Staff Report City of Richmond, Virginia

Commission of Architectural Review

2. COA-109601-2022	Final Review Meeting Date: 4/26/2022	
Applicant/Petitioner	Taylor Bergman	
Project Description	Rebuild a rear deck and fence, and construct a pergola.	
Project Location	3016	
Address: 3108 E. Broad St.	3018 3020	
Historic District : St. John's Church	3102 3104	
High-Level Details:	3102 3104	
The applicant proposes to remove an existing rear deck, shed, and privacy fence.	• 3108 • 3110 • 5t John's Church	
The applicant proposes to construct a new rear deck, privacy fence, pergola, and carport.	3116 3118 3101 3100	
The majority of the materials selected for new construction consist of vinyl, PVC, and composite decking.	3103 3105 3109 3111 3113 Chimborazo Park 3200	
Staff Recommendation	Approval, with Conditions	
Staff Contact	Alyson Oliver, alyson.oliver@RVA.gov, 804-646-3709	
Previous Reviews	None	
Conditions for Approval	Staff approval of this request, with the following conditions:

Figure 3. View of existing rear yard privacy fence, looking toward alley.

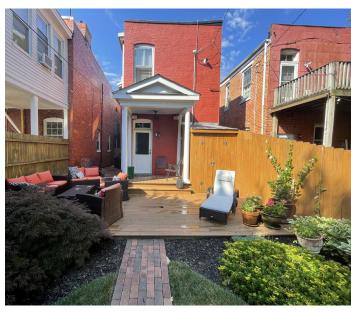
New Construction, Fences & Walls, pg. 51 #3	Privacy fences along the side and rear of a property should be constructed of wood of an appropriate design. Privacy fences are not appropriate in front of a historic building.	The applicant is also proposing to remove the existing wooden rear privacy fence and replace it with a new composite privacy fence. The guidelines specify the rear privacy fences in City Old and Historic Districts should be constructed of wood. Therefore, staff recommends that if the existing rear privacy fence is removed, it be reconstructed of wood and painted or stained a neutral color that complements the main building.
Fences Walls, pg. 78 #9	Rear-yard privacy fences should mimic traditional fence designs.	Specifications on the design of the rear privacy fence have not been provided. Staff recommends that the rear privacy fence incorporate a traditional privacy fence design with vertically-oriented pickets. Final design to be submitted to staff for review and approval.

Fences & Walls, pg. 78 #10	Wooden fences should be repaired and painted as needed. Existing picket designs should be matched when replacement is necessary.	The applicant is proposing to remove and replace the existing rear privacy fence. Staff encourages the applicant to consider repairing the existing fence, rather than complete replacement.

The pergola be constructed of wood and painted or stained a neutral color that complements the main building. Final colors submitted to staff for review and approval.	
	 The carport columns be wrapped in wood and painted or stained a neutral color to complement the main building. 	
	If the existing rear privacy fence is removed, it be reconstructed of wood and painted or stained a neutral color that complements the main building. Any new rear fencing must incorporate a traditional privacy fence design with vertically-oriented pickets. Final design and colors to be submitted to staff for review and approval.
